Access Compliance Report Public Rights-of-Way (Curb Ramps)

Main Street: SOL_ST Cross Street: LODEN_PASS Location: NW

ADA ID: RPRK211104132205 Ramp Type: Type 4 - Parallel Initial Pass/Fail: Fail Overall Compliance: No Severity Score: 15

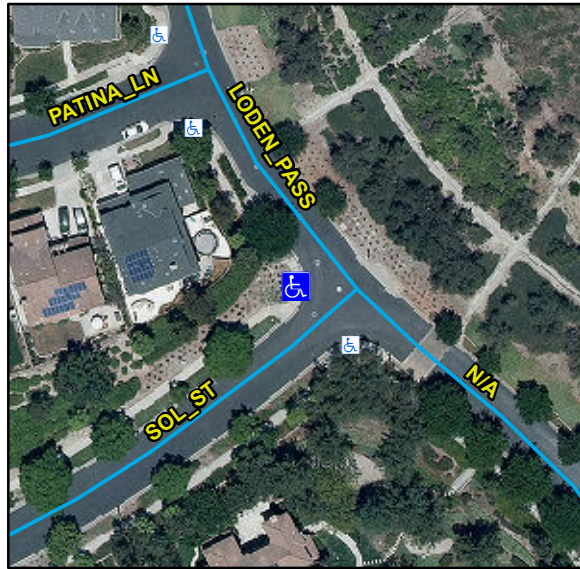
Compliance	Description	Data	Compliance	Description	Data
N/A	Ramp Length LT (in)	124	N/A	Ramp Length RT (in)	137
Yes	Ramp Width LT (in)	54	Yes	Ramp Width RT (in)	54
Yes	Ramp Run Slope LT (%)	1.2	No	Ramp Run Slope RT (%)	11.6
Yes	Ramp Cross Slope LT (%)	1.4	Yes	Ramp Cross Slope RT (%)	0.2
N/A	Landing Present	N/A	N/A	DWS Provided	N/A
N/A	Landing Length (in)	N/A	N/A	DWS Contrast	N/A
N/A	Landing Width (in)	N/A	N/A	DWS Length (in)	N/A
N/A	Landing Run Slope (%)	N/A	N/A	DWS Full Width	N/A
N/A	Landing Cross Slope (%)	N/A		DWS Offset Type	N/A
N/A	Landing Movement Obstructed?	N/A	N/A	DWS Offset Left (in)	N/A
	Landing Movement Type	N/A	N/A	DWS Offset Right (in)	N/A
N/A	Landing Shared	N/A			
N/A	Clear Space	Yes			
N/A	Clear Space To Crosswalk (in)	N/A			
N/A	Marked Crosswalk 1	No	N/A	Marked Crosswalk 2	No
	Crossing 1 Direction	S		Crossing 2 Direction	E
	Marked Crosswalk 1 Width (in)	N/A		Marked Crosswalk 2 Width (in)	N/A

N/A	Ramp Inside Crosswalk 1	N/A	N/A	Ramp Inside Crosswalk 2	N/A
	Crossing 1 Slope (%)	7.3		Crossing 2 Slope (%)	3.8
	Crossing 1 Cross Slope (%)	6.4		Crossing 2 Cross Slope (%)	2.6
N/A	Gutter Ponding	N/A	N/A	Curb Slope	13.7
Yes	Gutter Lip Height (in)	0		Road Run Slope (%)	4.7
N/A	Gutter Run Slope (%)	N/A		Road Cross Slope (%)	3.6
N/A	Gutter Cross Slope (%)	N/A	Yes	Perpendicular Joint Present	Yes
Yes	Overall Surface Condition	Acceptable			
	Cross Gutter Present?	No		Spandrel Present?	No
	Replace Cross Gutter?	N/A		Replace Spandrel?	N/A

Remove & Replace Curb Ramp With Two New Directional Ramps or Equivalent.

R304.3.2, STD 1115
